PUBLIC INTEREST REVIEW FOR GROUNDWATER APPLICATIONS

TO: Water Rights Section Date 6/15/2020
 FROM: Groundwater Section Benjamin Scandella, Jen Woody
Reviewer's Name
 SUBJECT: Application G-18757 Supersedes review of 3/22/2019, 10/18/2019
Date of Review(s)

A. GENERAL INFORMATION: Applicant's Name: **TOUCHMARK HEIGHTS LLC** County: **WASHINGTON**

Figure 2: Well Location Map

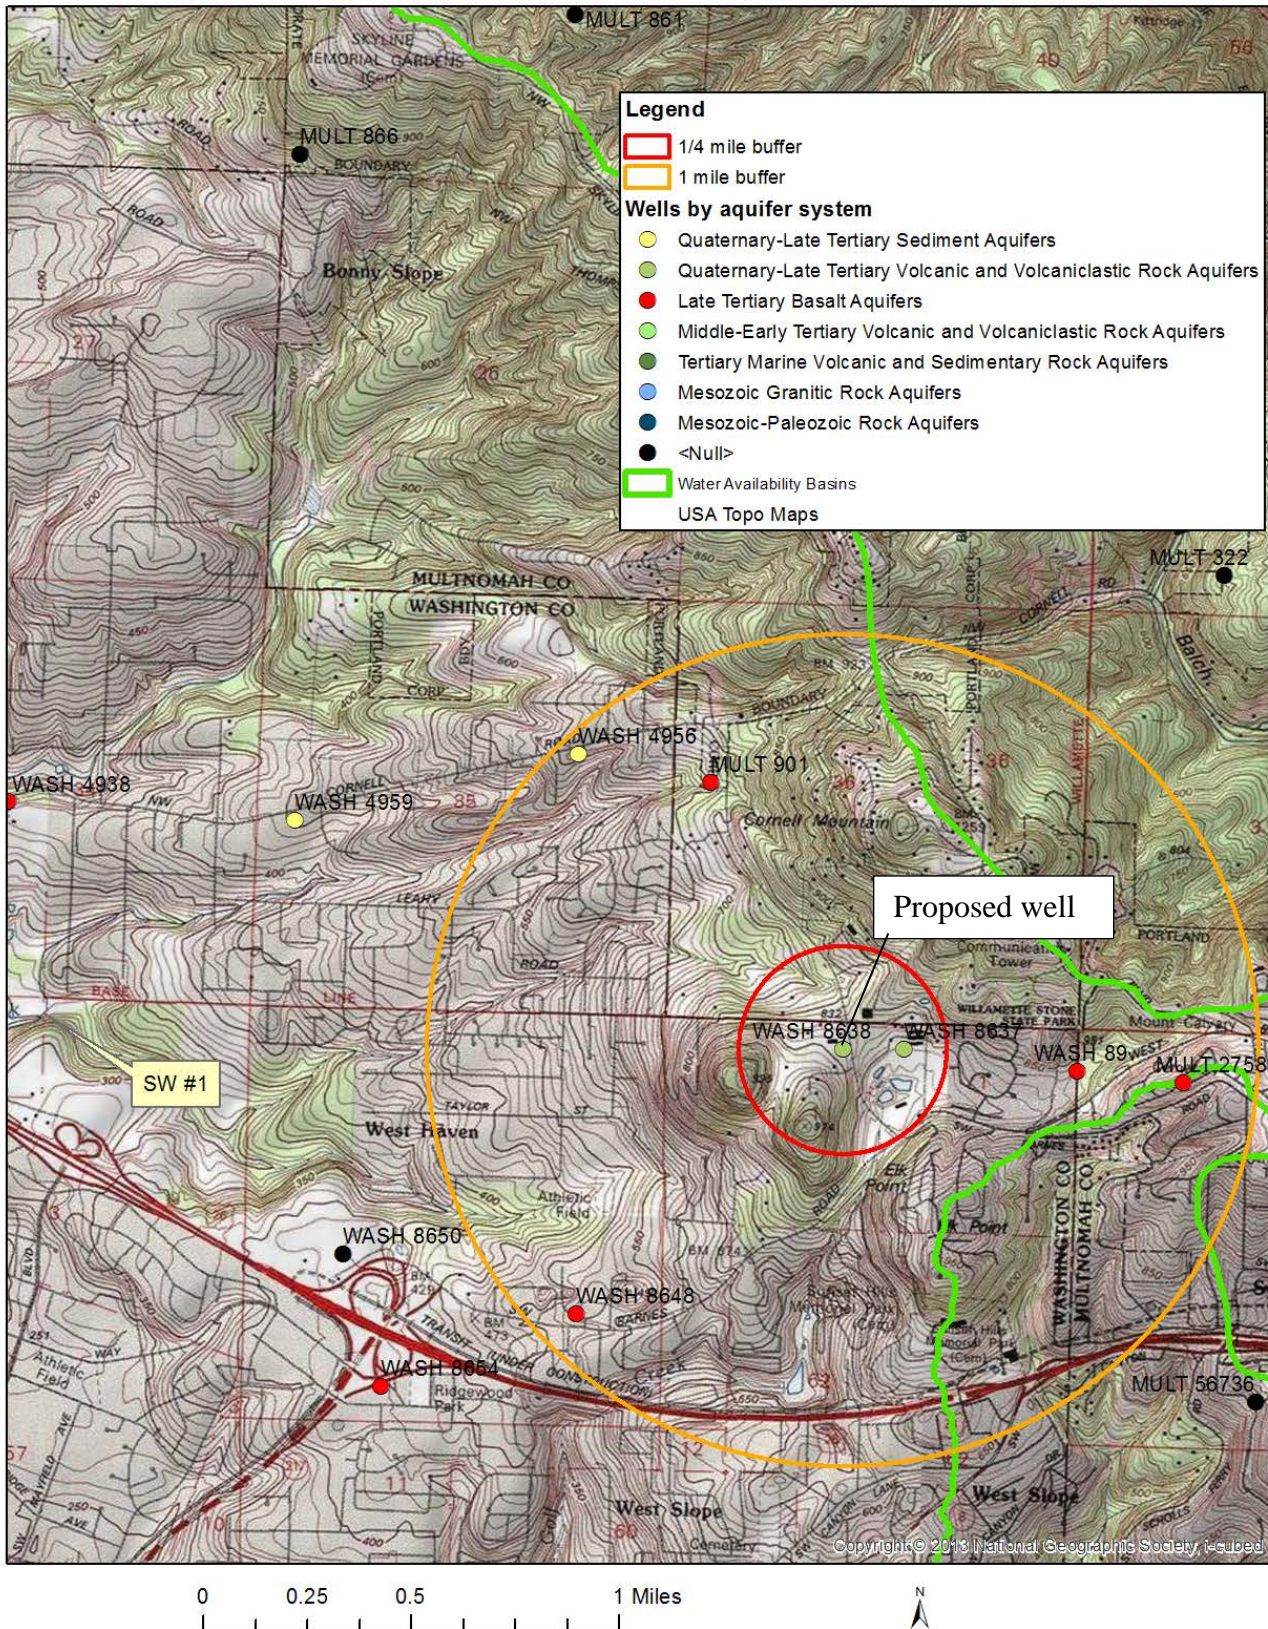
A4. **Comments:** The applicant's proposed well is located in the west foothills of the Tualatin mountains, about 1 mile northwest of Sylvan. The application suggests that the source aquifer would be "BEDROCK," but geologic analysis suggests that the well is completed into the Quaternary-Late Tertiary Volcanic and Volcaniclastic Aquifer System.
*water level and yield are estimated based on WASH 8638, which is adjacent to the proposed well.

Figure 3: Hydrograph of Water Levels in Nearby Wells

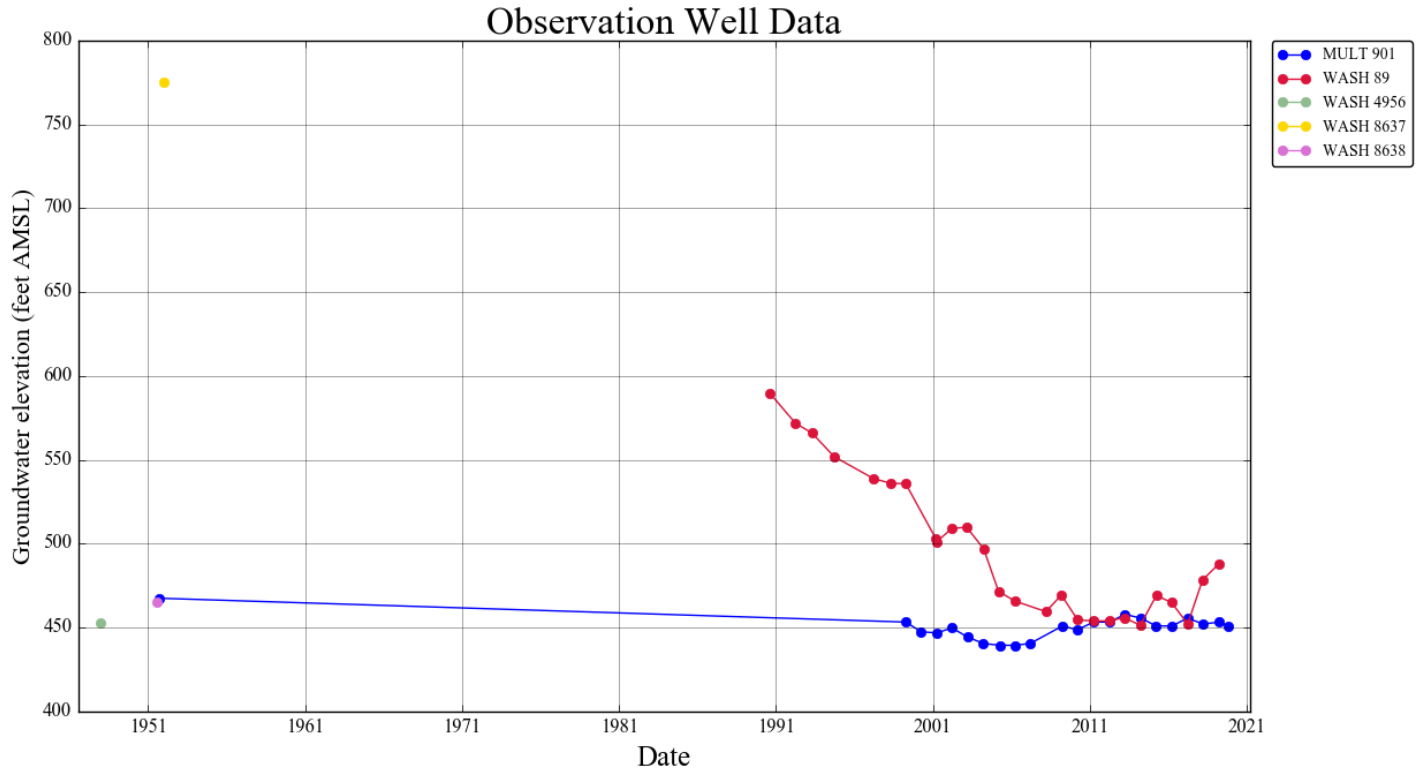
In the original GW review, the QLTV Aquifer System was found to be connected with the Columbia River Basalt Group (CRBG) Aquifer System based on coincidence of water levels between WASH 8638 and MULT 901. Given the best available information at that time, water levels over 200 feet higher in MULT 901 in the 1970s and 1980s indicated excessive declines, such that further extraction would have been beyond the capacity of the aquifer. A field visit and measurements collected by OWRD staff on 10/11/2019 suggested that the high water levels originally reported in MULT 901 were likely measured in a different well. Therefore, the subject well and MULT 901 show a relatively stable water level trend over the period of record. Recent divergence of water levels in MULT 901 and WASH 89 suggest that those wells access different aquifers. Considering this more recent information, the original finding, that water is not available within capacity of the resource, was reversed. The lack of water level data in the QLTV in the vicinity of WASH 8638 warrants including the permit conditions indicated in section B1di above to monitor the resource and protect existing users.
